Project	IEEE 802.16 Broadband Wireless Access Working Group < http://ieee802.org/16 >	
Title	Harmonized H-ARQ MAP IE Corrections	
Date Submitted	2005-03-17	
Source(s)	<p>Yeongmoon Son, Changhoi Koo, Jungje Son, Steve Lee, Jonghyun Won, Geunhwi Lim, Wonil Roh, Jiho Jang</p> <p>Samsung Electronics Co. Ltd.</p> <p>Erik Lindskog, Kamlesh Rath, Dave Garrett and Brett Schein.</p> <p>Beceem Communications, Inc.</p> <p>Wen Tong, Mo-Han Fong</p> <p>Nortel Networks</p> <p>Yigal Eliaspur, Jose Puthenkulam, Randall Schwartz</p> <p>Intel</p> <p>Bin-Chul Ihm, Jin Young Chun</p> <p>LGE</p> <p>Mark Cudak, Kevin Baum</p> <p>Motorola</p> <p>Sean Cai, Jason Hou</p> <p>ZTE</p>	<p>Voice: +82-31-279-5845 FAX: : +82-31-279-5130 ym1004.son@samsung.com</p>
Re:	IEEE P802.16e/D6	
Abstract	Harmonized H-ARQ MAP IE Corrections	
Purpose	Adoption of proposed changes into P802.16e /D6	
Notice	This document has been prepared to assist IEEE 802.16. It is offered as a basis for discussion and is not binding on the contributing individual(s) or organization(s). The material in this document is subject to change in form and content after further study. The contributor(s) reserve(s) the right to add, amend or withdraw m

Figure B Reduced CID Decoding

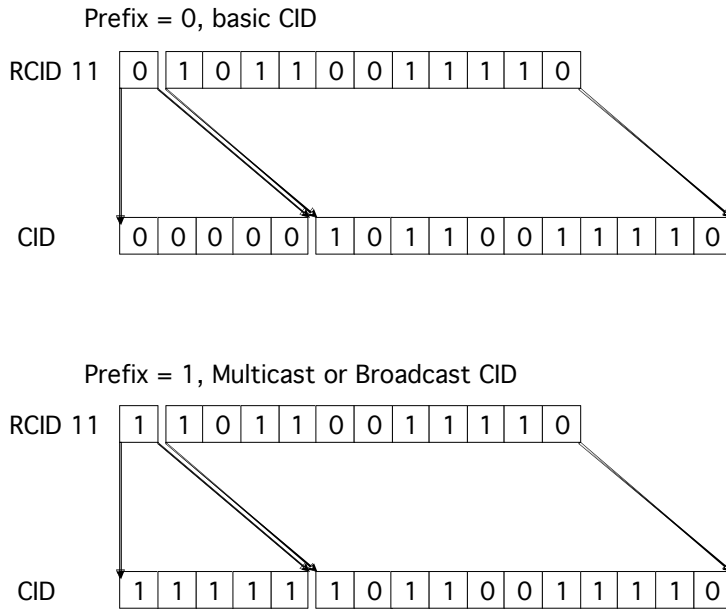
[Add the following text in the section 8.4.5.3.21.2 Reduced CID IE]

Figure B shows the decoding of reduced CID when the RCID_Type is set to 3.

Table A presents the format of reduced CID. BS may use reduced CID instead of basic CID or multicast CID to reduce the size of H-ARQ MAP message. The type of reduced CID is determined by BS considering the range of basic CIDs of SS connected with the BS and specified by the RCID_Type field of the Format Configuration IE. The reduced CID is composed of 1 bit of prefix and n-bits of LSB of CID of SS. The prefix is set to 1 for the broadcast CID or multicast CID and set to 0 for basic CID. The reduced CID can not be used instead of transport CID, primary management CID or secondary management CID.
